**CITY OF LA VISTA**  
**MAYOR AND CITY COUNCIL REPORT**  
**AUGUST 18, 2015 AGENDA**

<b>Subject:</b>	<b>Type:</b>	<b>Submitted By:</b>
APPLICATION FOR PUD ORDINANCE AMENDMENT, ◆ RESOLUTION (2) FINAL PUD PLAN & CONDITIONAL USE PERMIT— COMFORT SUITES LOT 1, SOUTHPORT EAST REPLAT TWELVE (NE OF McDERMOTT PLZ. & EASTPORT PKWY.)	ORDINANCE (1) RECEIVE/FILE	ANN BIRCH COMMUNITY DEVELOPMENT DIRECTOR

**RECOMMENDATION REPORT**

CASE NUMBER: 2015-CUP-02  
2015-PUD-04

REVISIONS  
DATE: 12-03-14  
DRAWN: PROJECT NO.:  
PWP: PP  
TITLE: ELEVATIONS  
DWS FILE: 16002-Elev  
SHEET NO.: A3.1

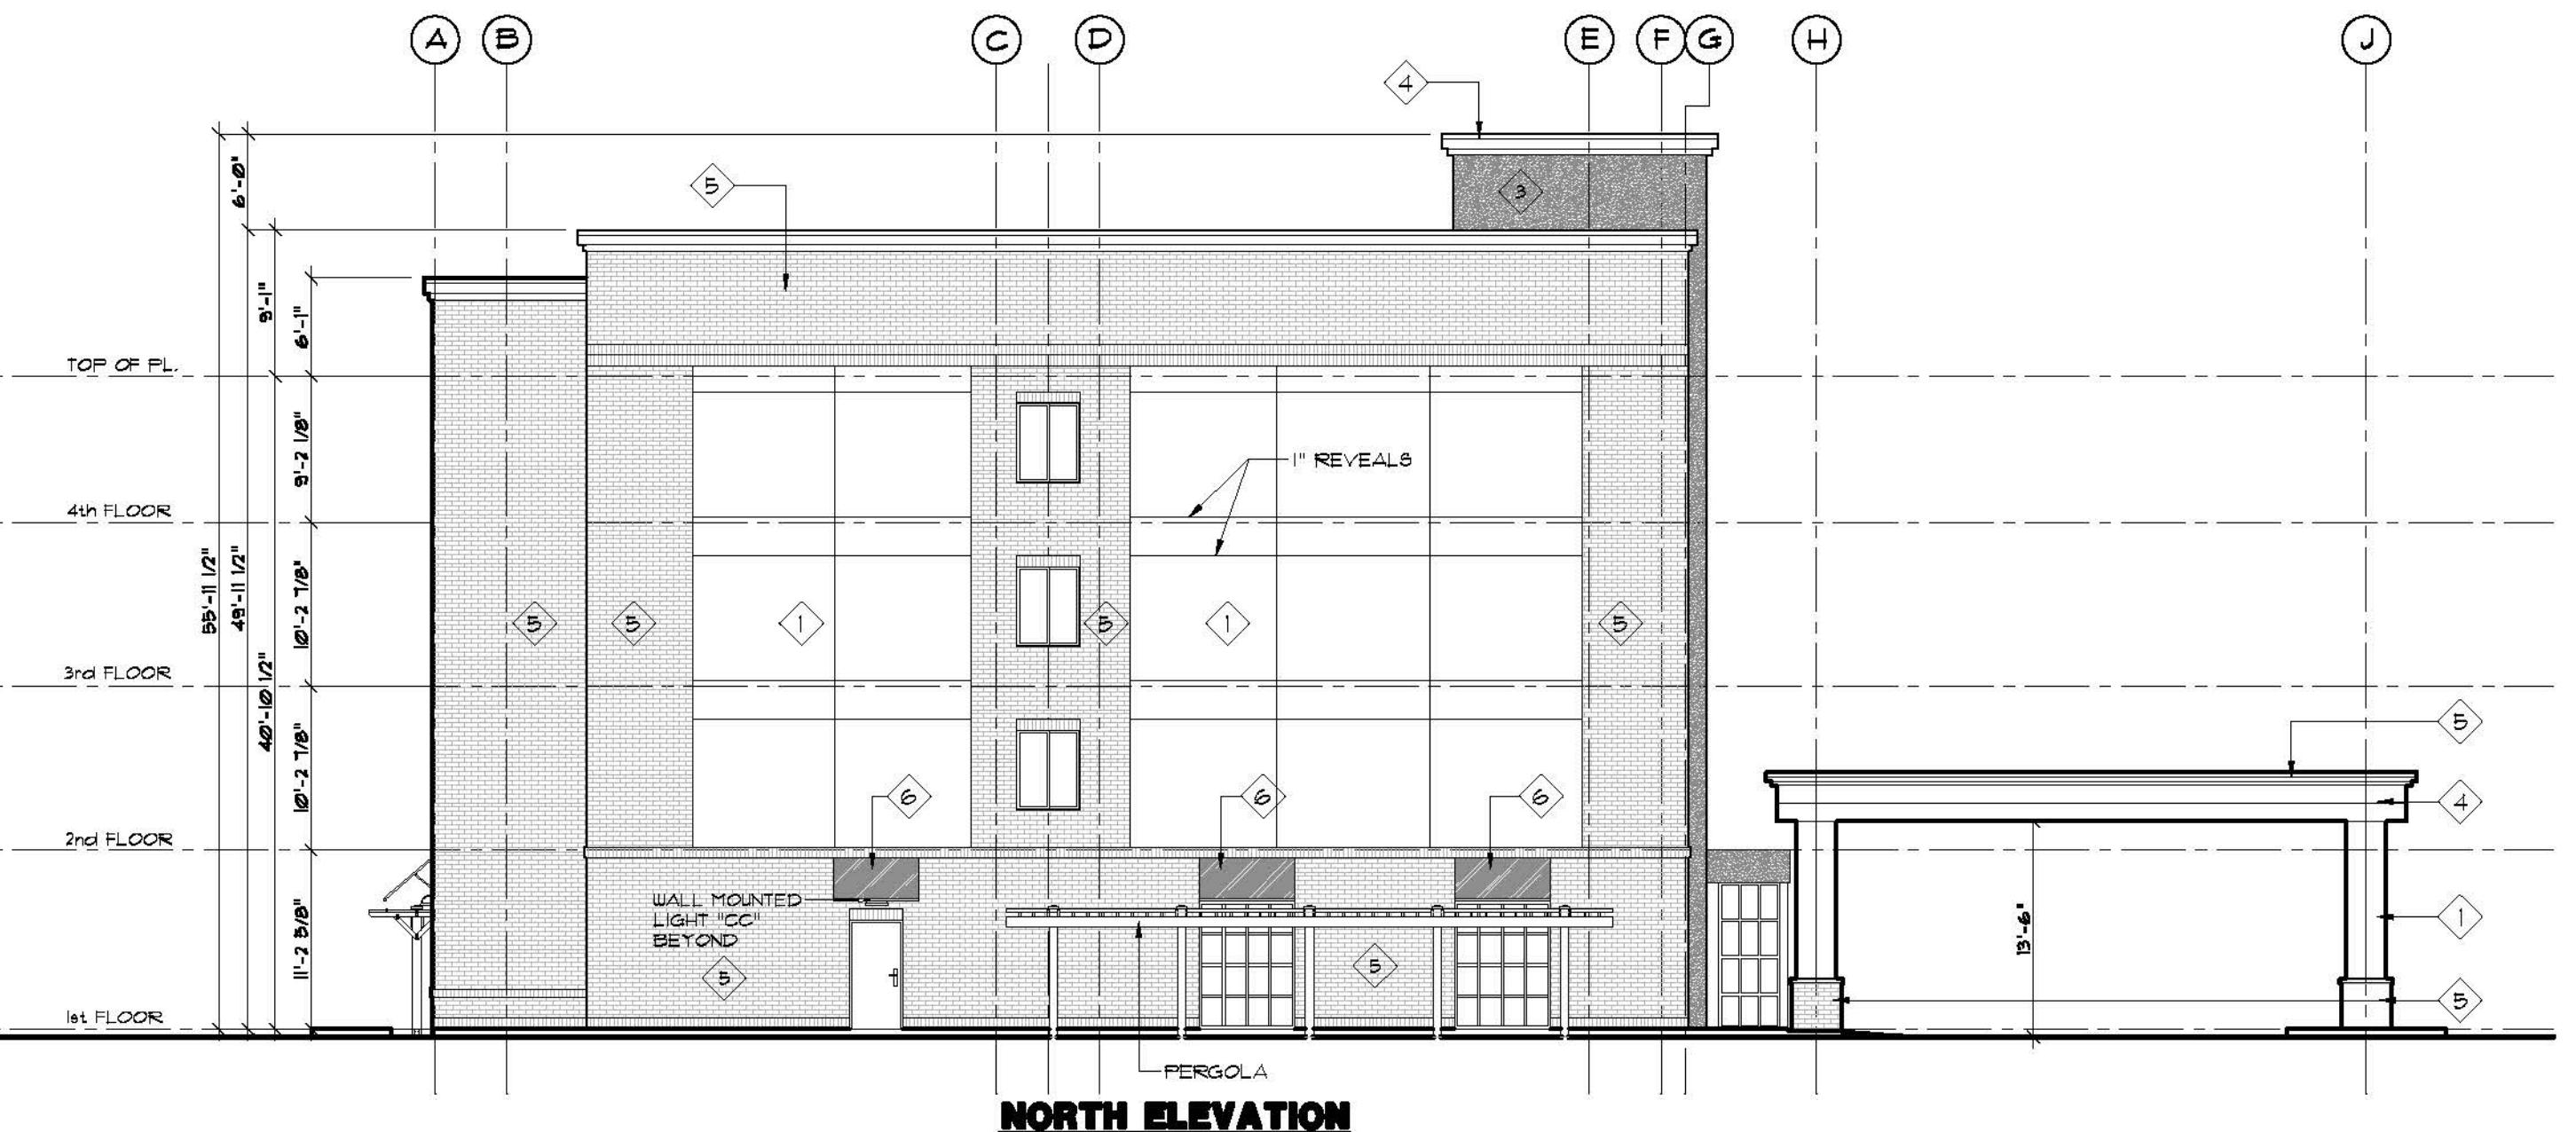
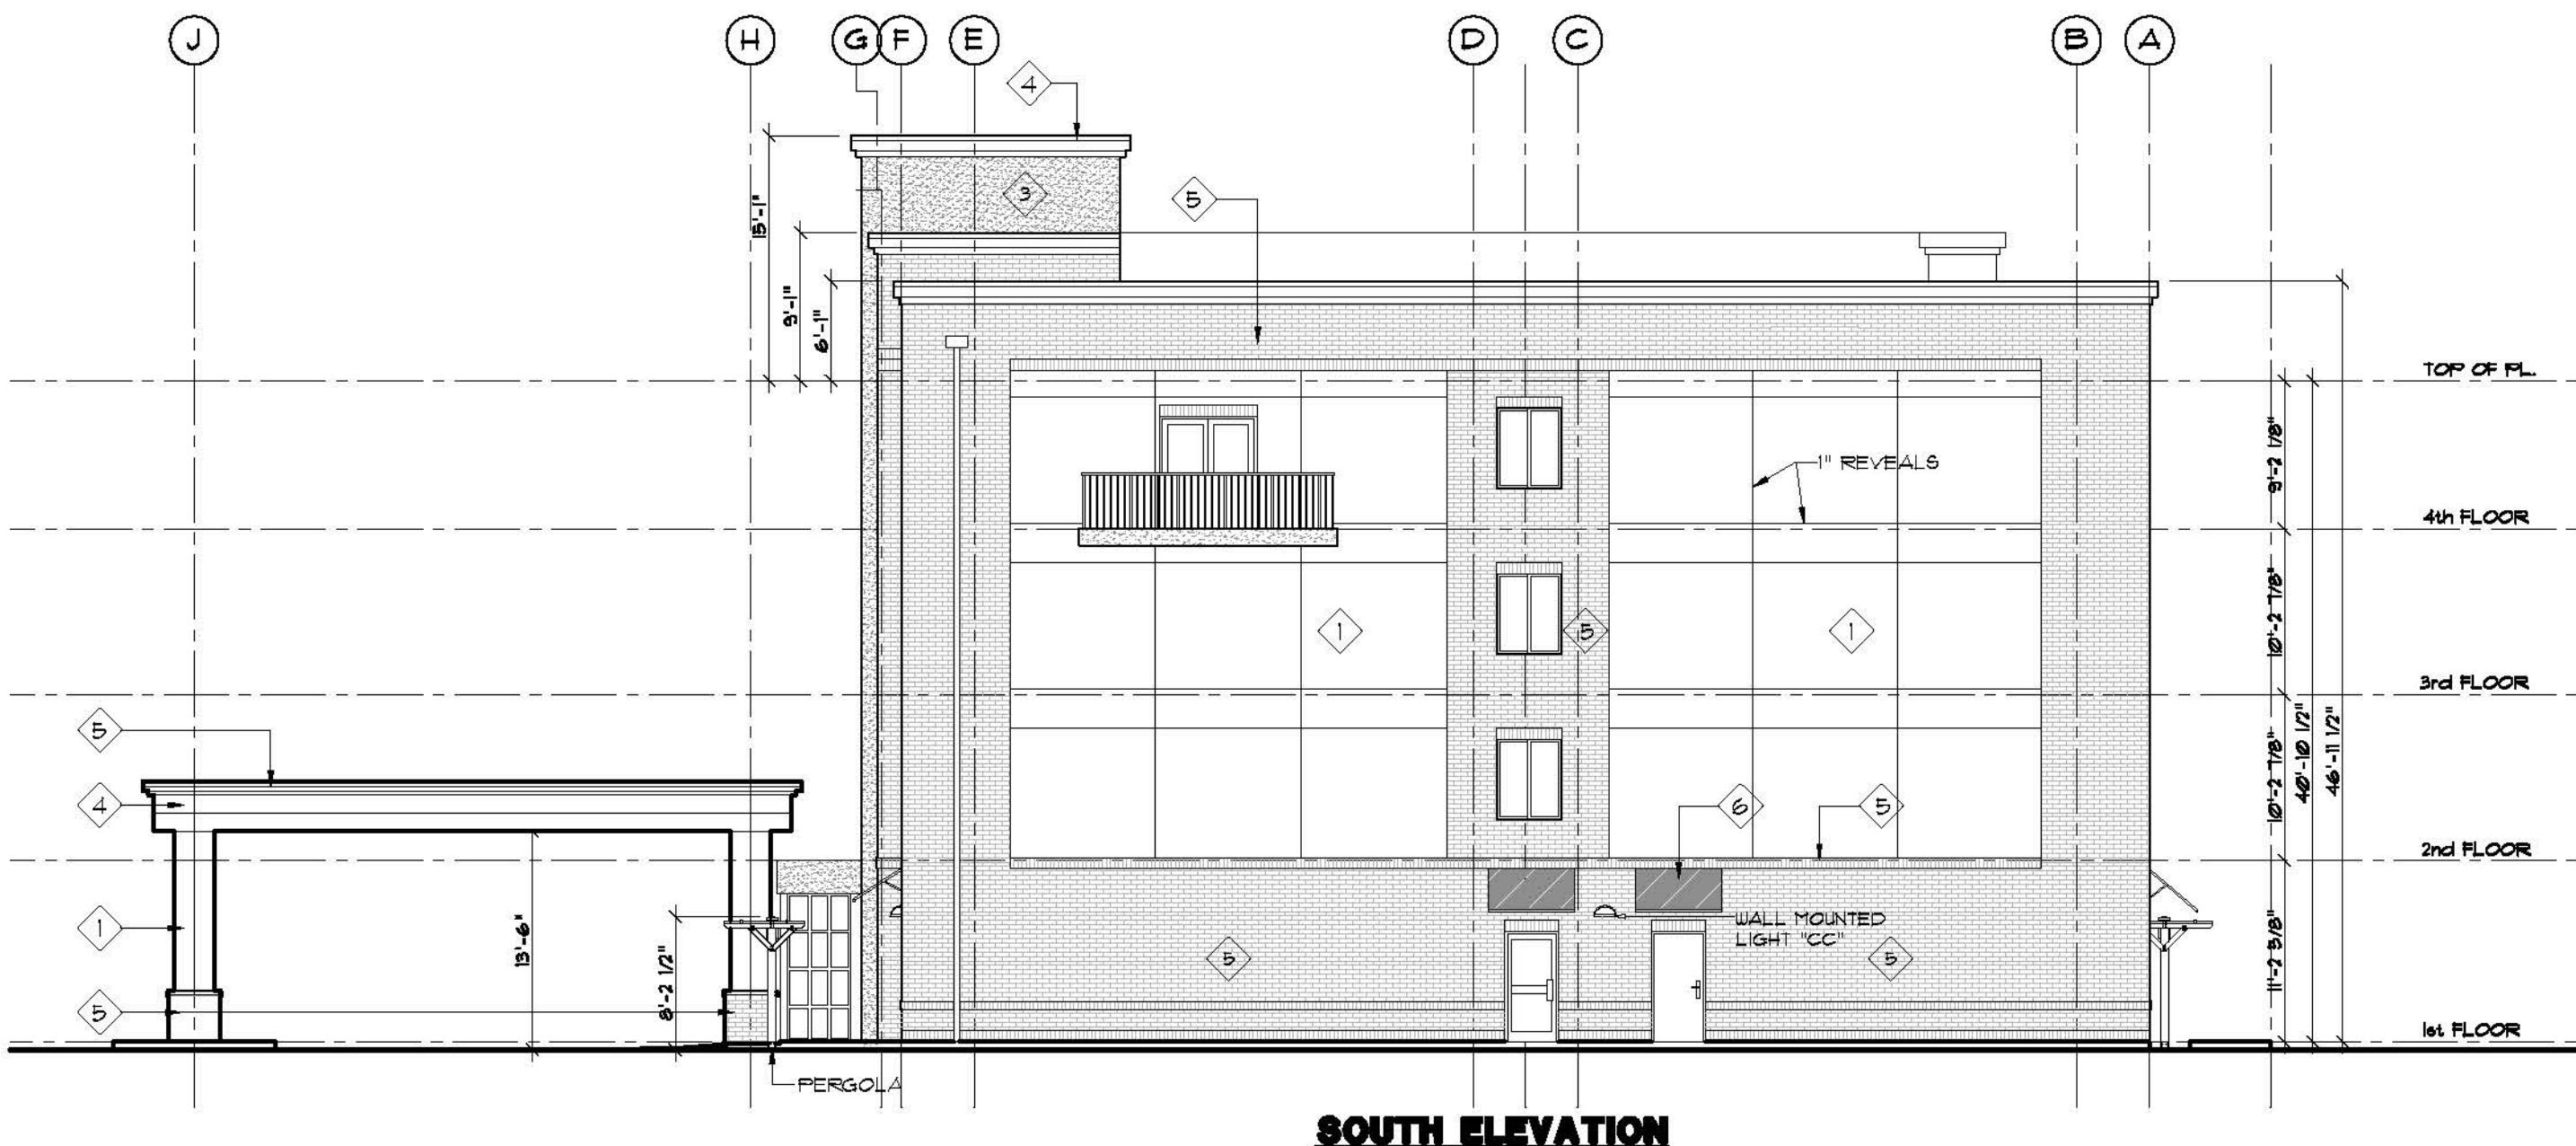
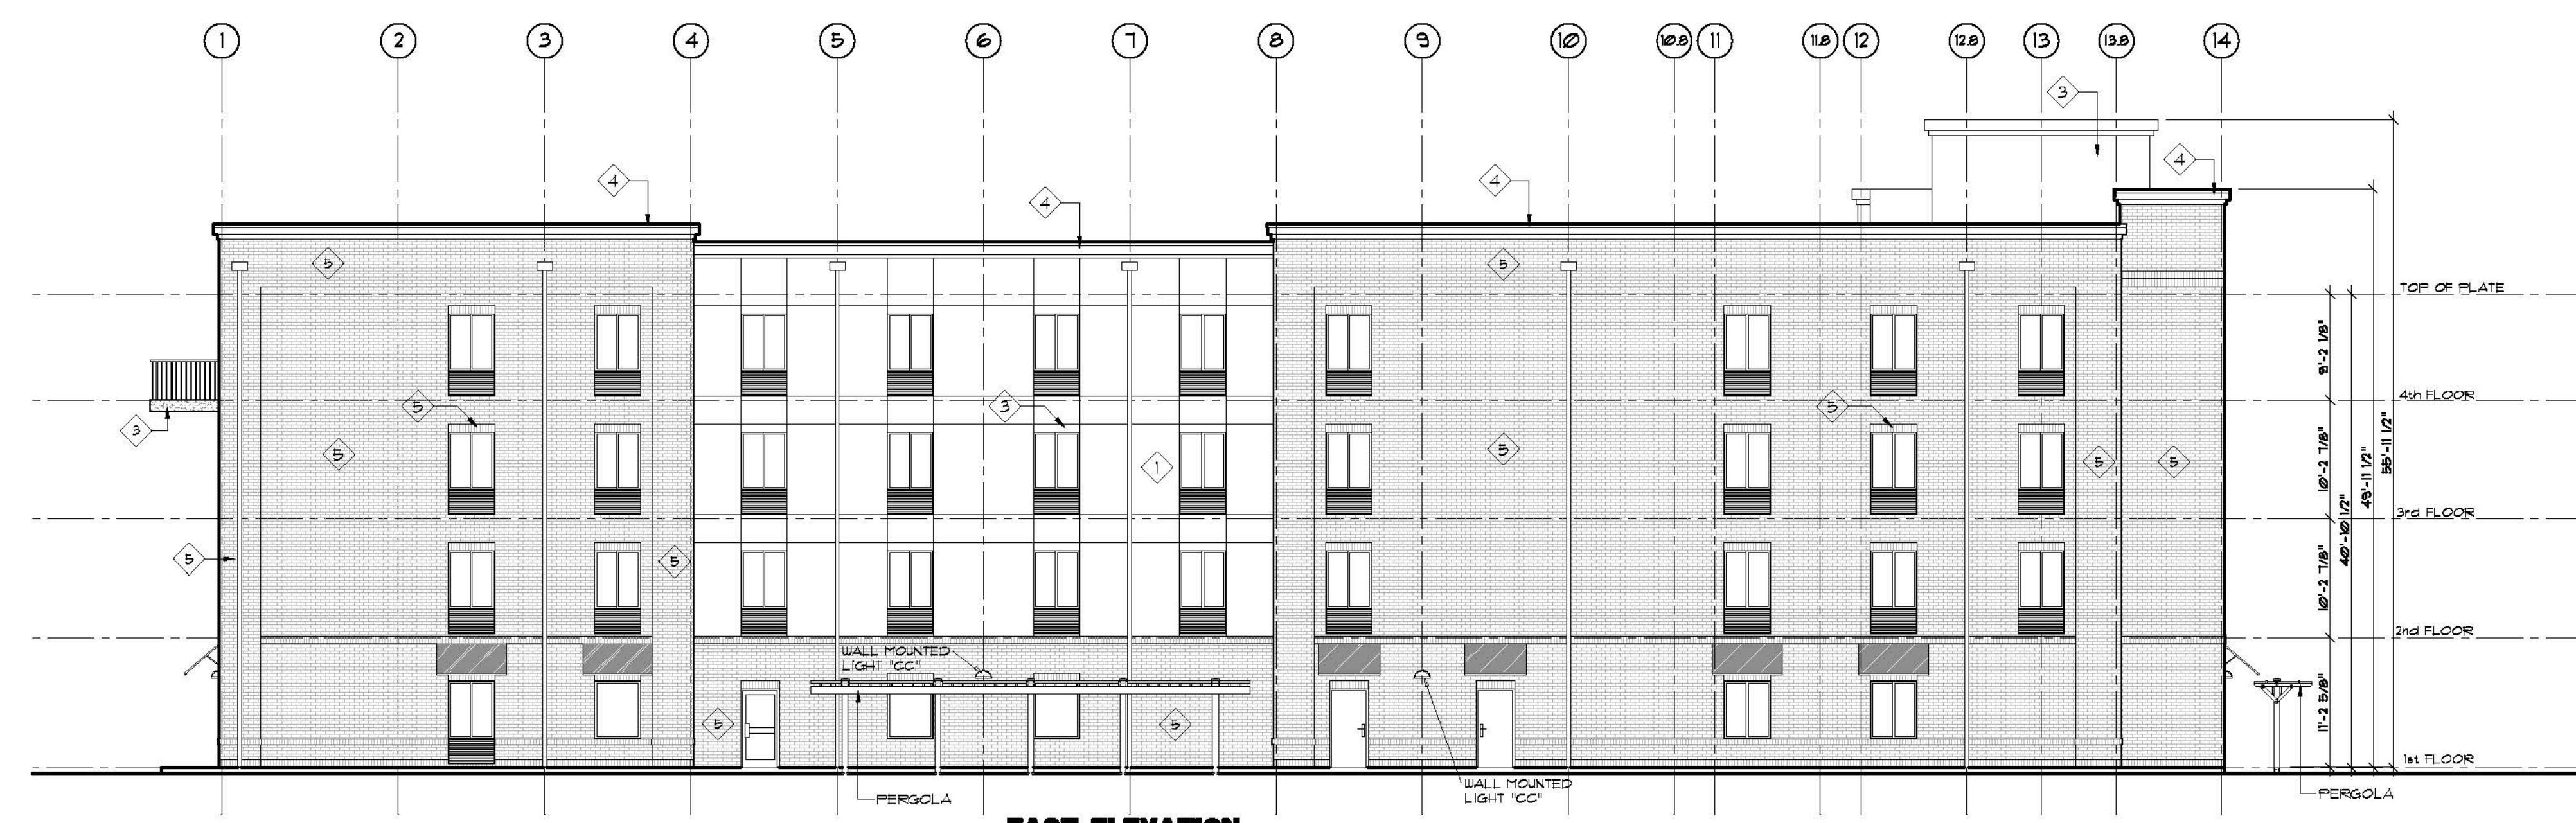
The PUD allows for a maximum height of 55 feet. The elevation views show a maximum height of 55'-11 1/2".

4. East Elevation – back side of entry tower element should be noted as 3, Mannered Gold.
5. Awnings are required to be fabric. Material sample received was paint on sheet metal. Submit actual sample of fabric awning material for approval. Recommend using an accent color for the awnings as there is a lot of dark brown happening on the base of the building without much contrast. Some more “Mannered Gold” could be a nice accent.

6. Are the soldier course brick bands an accent brick color or same as field? This appears to be an opportunity for some added detail and contrast.
7. Are the windows completely in brick going to have a sloped rowlock sill similar to head detail and some of the banding on the base?

1. Brick will be Brown Brick by Sioux City Brick in Manganese Velour finish.  
Please see revised finish schedule.
2. White guestroom windows
3. Note added to sheet A3.1.
4. Back side of entry tower color changed to color # 3, Mannered Gold.
5. Would like to keep all awning in Urbane Bronze instead of a lighter color.  
Will provide sample of canvas material painted in Urbane Bronze finish.
6. Same as field.
7. There is no space between the window sill and the PTAC grill to install sloped rowlock. There will be no banding at the base.
8. The window heads in EIFS area have been changed to Mannered Gold.
9. Exterior lighting locations now shown on building elevations.
10. Patio railing will be Urbane Bronze
